- A. Overheating at Idle RPM - MIE 230/260/340 and MCM 330 (B-W) Models
- B. Improved Spark Plug Boot for Thunderbolt IV (HEI) Ignition Systems - MIE 230/260/340 and MCM 898R/228R/260R/330 (B-W) Models
- C. Spark Plug Wire Positioning - MIE 230/260/340 and MCM 898R/228R/260R/330 Models
- D. Quicksilver Insulating Compound

NUMBER: 83-22

A. OVERHEATING AT IDLE RPM - MIE 230/260/340 and MCM 330 (B-W) MODELS

Figure 2. Installing New Tee Fitting

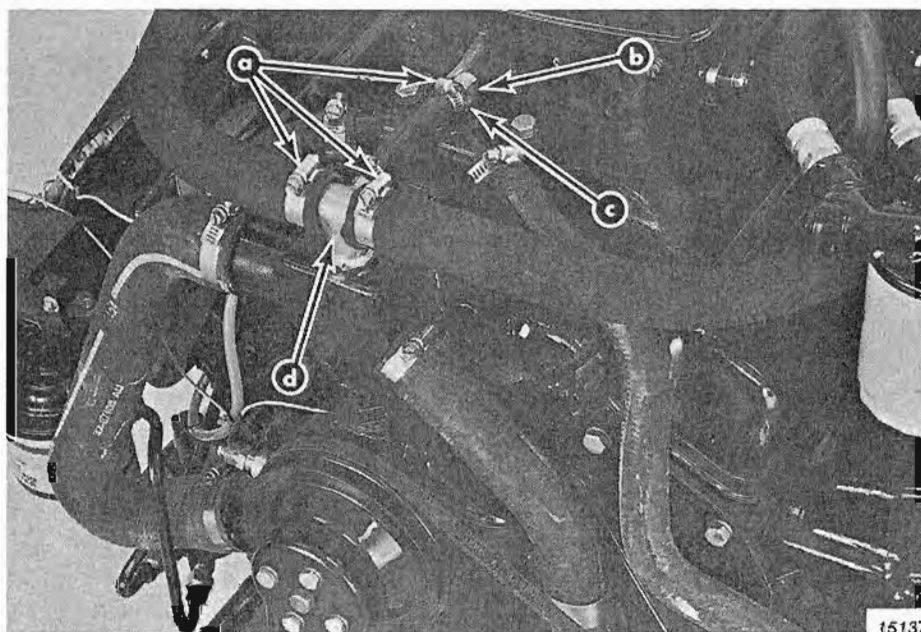
Under certain operating conditions, the above model engines may overheat at idle RPM. Usually by increasing engine RPM, the engine temperature will drop. If this condition exists, order a new tee-fitting (with poppet valves). Install as shown in Figures 1 and 2. Also, install a stainless steel restrictor plate between the exhaust manifold, as shown in Figure 3.

- a - Put Teflon Tape Around Threads and Install 22-98477A1 Tee Fitting
- b - Reinstall Hoses and Clamps

Figure 1. Removing Tee Fitting and Air Bleed Hose

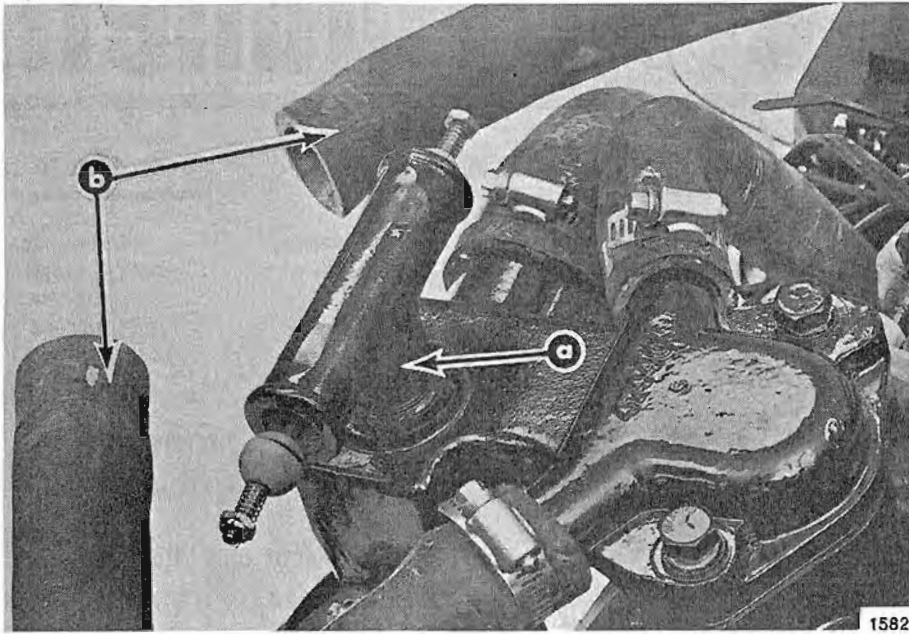
- a - Remove Clamps and Hoses
- b - Remove 90° Elbow
- c - Install 1/8" Pipe Plug
- d - Remove Tee Fitting

Figure 3. Restrictor Plate Installation

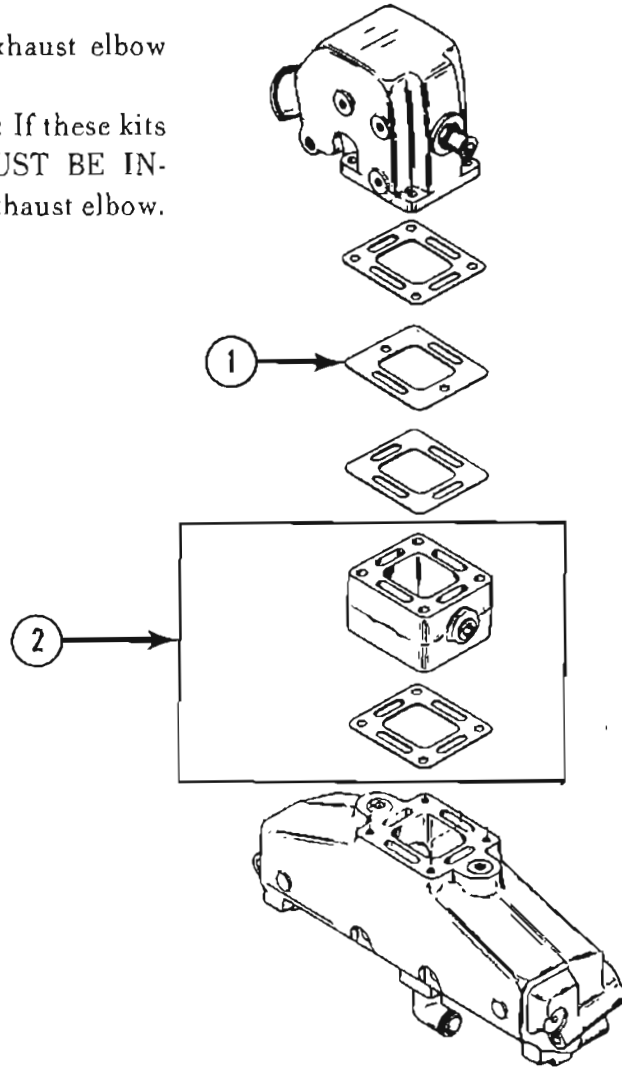
Earlier production and some dealers installed the tee-fitting but not the restrictor plates. It is recommended that when servicing these engines, the restrictor plate be added at that time. The serial number of engines affected are listed below. Engines above these serial numbers have both the tee-fitting and restrictor plates installed in production.

1. Install restrictor plate between exhaust elbow and manifold as shown.
2. 3" or 6" Exhaust Elbow Riser Kits: If these kits are installed, restrictor plate **MUST BE INSTALLED** between the riser and exhaust elbow.

Figure 4. Spark Plug Wire Positioning

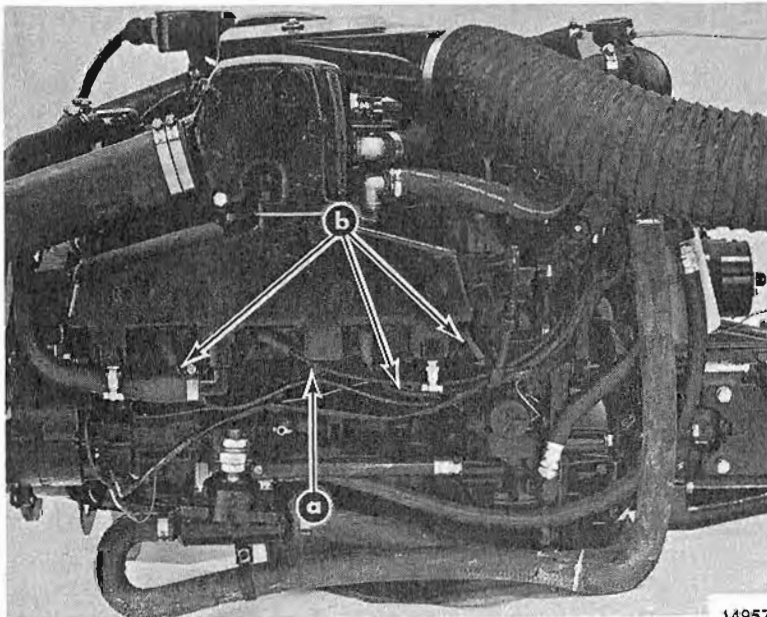
Care must be taken when installing spark plug wires or removing the distributor cap. If the spark plug wires are not positioned correctly, they can be too close to the exhaust manifold or actually lay against the manifolds, causing the wire to burn. See Figure 4 for correct positioning.

- a - Incorrect
(Too Close to Exhaust Manifold)
- b - Correct
(Boot Pointed Downward)

After servicing spark plugs, wires or distributor cap, pull slack, in spark plug wires, TOWARD spark plug. Point spark plug boot DOWNWARD and make sure spark plug wire does not come in contact with exhaust manifold(s).
